SUBJECT: Addendum to Responses to Questions on Addendum 2 to EPRI
Performance Prediction Program Topical Report TR-103237-R2
Thrust Uncertainty Method

PROJECT NUMBER: 689

**Addendum to Responses to NRC Comments on
Addendum 2 to EPRI TR-103237-R2**

Figure 1. Histogram of Prediction Ratios (Actual and "Mirrored")

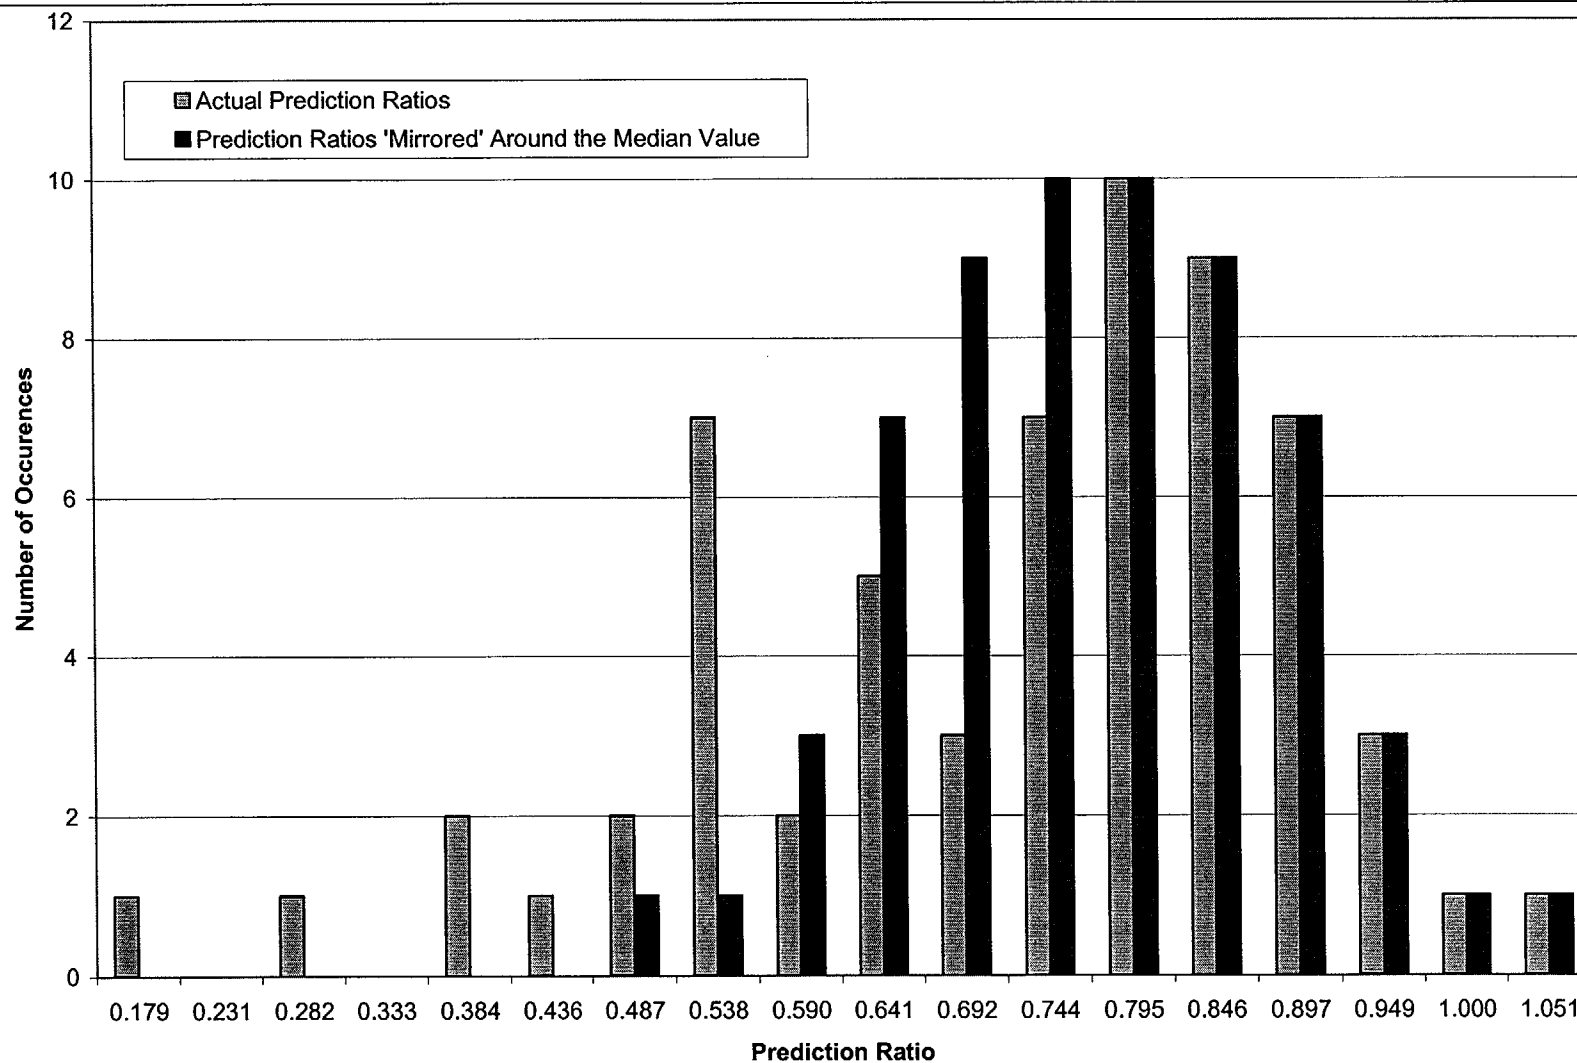
- New data points (that are less than the median value) are added to the population to create a "mirror" image of the values above the median. For each value greater than the mean (by an amount x), a new value is added to the population that is x less than the median. The data set created in this way, which has both an average and a mean equal to 0.7435, is shown in the second column of Table 1. Figure 1 shows histograms of the actual prediction ratio data and the prediction ratios "mirrored" around the median.

- The standard deviation (s) of the new data set is calculated to be 0.1151.
- A K-value of 2.01 is calculated, with z_c equal to 1.645 (from Table A-2 of Reference 2), z_p equal to 1.645 (from Table A-2 of Reference 2) and n equal to 62 (the number of data points). The equations are shown below.

Since this value is less than 1.0, there is more than 95% confidence that a prediction ratio of 1.0 bounds 95% of the valve population, given the data set in the second column of Table 1.
